Appl. No.: 10/560,391  
Amdt. Dated March 19, 2010  
Reply to Office Action Mail-Dated April 6, 2009

**Amendments to the Drawings:**

### REMARKS/ARGUMENTS

FIG. 1

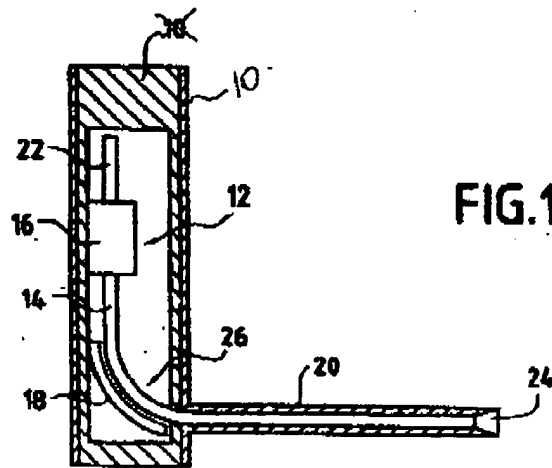
- Figure 1 reference number 10 is moved so it now points to the borehole;
- Figure 4 – relabeled as separate figures at Figures 4A1 and 4A2;
- Figure 5 – relabeled as separate figures as Figures 5A and 5B;
- Figure 6 relabeled as separate figures as Figures 6A and 6B;
- Figure 7 – relabeled as separate figures as Figures 7A and 7B;
- Figure 8 – relabeled as separate figures as Figures 8A and 8B;
- Figure 9 relabeled as separate figures as Figures 9A and 9B;
- Figure 10 – relabeled as separate figures as Figures 10A and 10B;
- Figure 12 – added reference numbers 31 for successive cells, 73, 75 for axial links and 80, 82 for rings;
- Figures 13A,B,C – added reference numbers 73, 75 for axial links; and
- Figure 14 – added lines to depict the main hole 10 and the lateral hole 12, and adjusted lead lines for 10, 12 to extend therefrom.

4. Applicant has amended Figures 1 and 14 to properly depict the main hole 10 and the lateral hole 20. In Figure 1, the reference character 10 was moved to properly point to the main hole 10. In Figure 14, lines depicting the main and lateral holes were added with lead lines of reference characters 10 and 20, respectively, extending therefrom. Support for these amendments are found at paragraph [0072] and [0092] of the specification.

FIG. 4A1

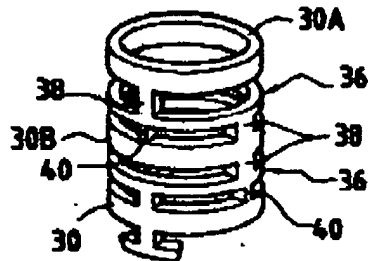
6. a. Applicant has canceled Claim 31 thereby rendering moot this objection.
6. b. Applicant has amended Figure 4A such that each figure is labeled 4A1 and 4A2. Applicant has also amended paragraph [0061] of the specification to indicate that 4A1

shows an implementation in an unloaded position, and 4A2 shows an implementation in a loaded position. A corresponding amendment has been made to paragraph [0078] to indicate the new figure numbers.

FIG. 5A

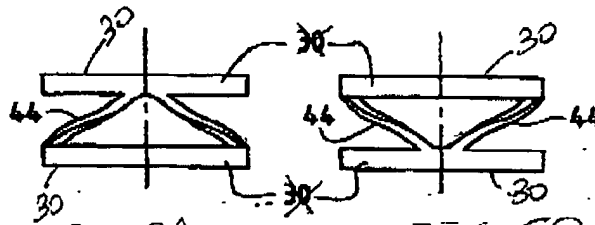
6. c. Applicant has amended Figure 5 to identify each figure as 5A and 5B, and Figure 6 to identify each figure as 6A and 6B as requested. Corresponding changes have been made to paragraphs [0062,63] of the specification.

6. d. As indicated in 6c above, Applicant has amended paragraph [0063]. This paragraph now indicates that FIG. 5B is the same implementation of FIG. 5A rotated 90 degrees. Similar amendments have been made for FIGS. 6-10.

6. e. The Examiner suggests that reference character '30' in Figure 5 cannot be used as a reference character for in separate figures. Applicant has amended Figures 5A-9B such that the reference characters are used separately for each figure.

FIG. 6A

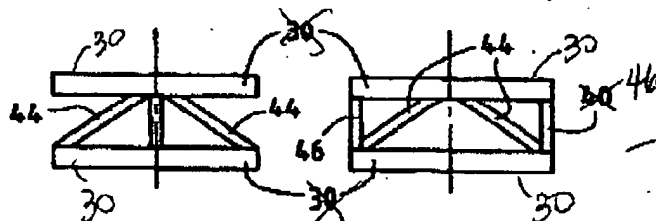
6. f. The Examiner has indicated that axial links and load supports are connected at both ends to adjacent rings 30 which would prevent flexion between adjacent rings 30 in Figs. 6-10. Applicant respectfully disagrees. First, the axial links 48 of Figure 7 are detached from ring 30 at one end 50 (see paragraph [0084]) and the axial links 56, 56' of Figure 9 are detached from the ring 30 at one end (see paragraph [0087]). Second, as described, for example, at paragraph [0085] "the basic cell structure (two suggestive rings 30) has different bending stiffness at 90°. There is a rigid direction (due to the axial link 46, 48) and a soft direction at 90° thereto." Third, as further described, for example, at paragraph [0086], the supports 52 can be pushed towards the centre of the shaft, but other movements are possible." Thus, flexion is permitted as described with respect to Figures 6-10 (at least).

FIG. 8A

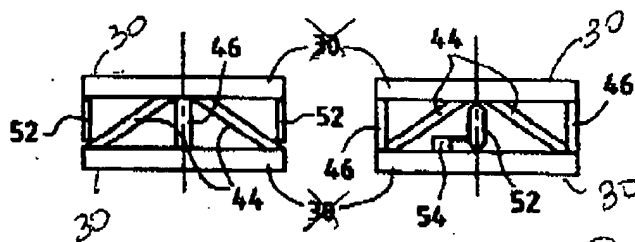
i. The Examiner suggests that FIG. 8 depicts the figure on the left with compression load supports connected to the upper ring, and the figure on the right illustrates the compression load support not connected to either the upper or the lower rings.

Applicant submits that Figures 8A and 8B, consistent with paragraph [0086] of the specification properly, depict compression load supports 52 positioned between the rings 30 and held in position by the spring mountings 54. Applicant further notes that paragraph [0065] has been amended to indicate that FIG. 8B is rotated 90 degrees from FIG. 8A.

FIG. 9A

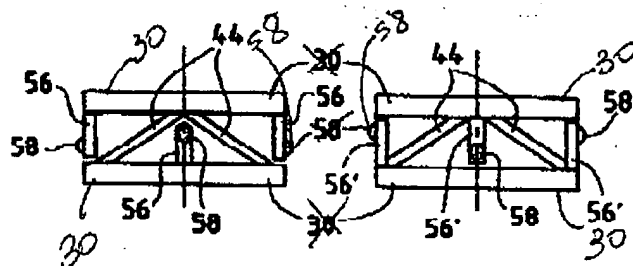
ii. The Examiner suggests that FIG. 9 depicts the figure on the left with load supports connected to the bottom ring, and the figure on the right illustrates the load supports connected to the upper ring. Applicant submits that Figures 9A and 9B,

consistent with paragraph [0087] of the specification, properly depict load supports 56 attached at one end to the upper ring, and load supports 56' attached at one end to the lower ring. Applicant further notes that paragraph [0066] has been amended to indicate that FIG. 9B is rotated 90 degrees from FIG. 9A.
